STAFF REPORT: JULY 9, 2025 MEETING
APPLICATION NUMBER: HDC2025-00300
VIOLATION NUMBER: 1019
ADDRESS: 1725 SEYBURN
HISTORIC DISTRICT: WEST VILLAGE
APPLICANT: TRACY LOWE
PROPERTY OWNER: TRACY LOWE
DATE OF PROVISIONALLY COMPLETE APPLICATION: 6/17/25
DATE OF STAFF SITE VISIT: 6/23/25

SCOPE: REPLACE HISTORIC WINDOWS, MULTIPLE EXTERIOR ALTERATIONS (WORK COMPLETED WITHOUT APPROVAL)

Photo 1 from site visit 6/23/25, staff. To the right of the house, the driveway is visible and at the end of the drive, the end of a one-story addition is visible. On that addition, an entry door, a storm door, a six-over-one window, and vinyl siding are visible.

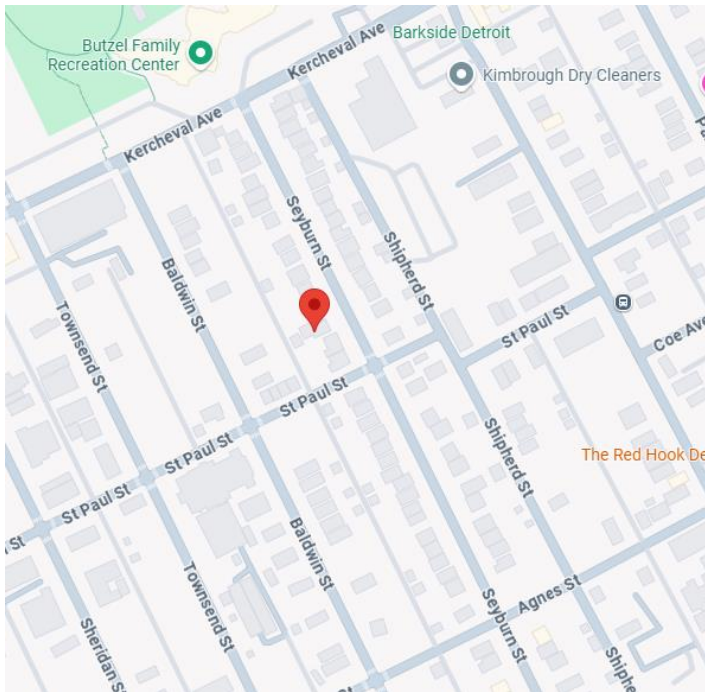
The 1 1/2-story dwelling at 1725 Seyburn is a bungalow with a deep, shaded front porch, a first-floor bay window looking onto the front porch, and two prominent second-story shed-roof dormers on the front façade. The house's first floor is brick, and the second floor is currently covered in white vinyl siding, including the front-facing dormers (the vinyl siding was recently installed without historic district commission approval). Some rear additions have been added to the house and they, too, are covered in recent white vinyl siding. A partially new concrete path leads to concrete steps to the front porch, which has a concrete floor. A newer (non-historic) Craftsman-inspired front door has been installed, an address plate has been hung on the brick column to the right of the front door, and a white rectangle has been painted onto the brick column just to the left of the front door.
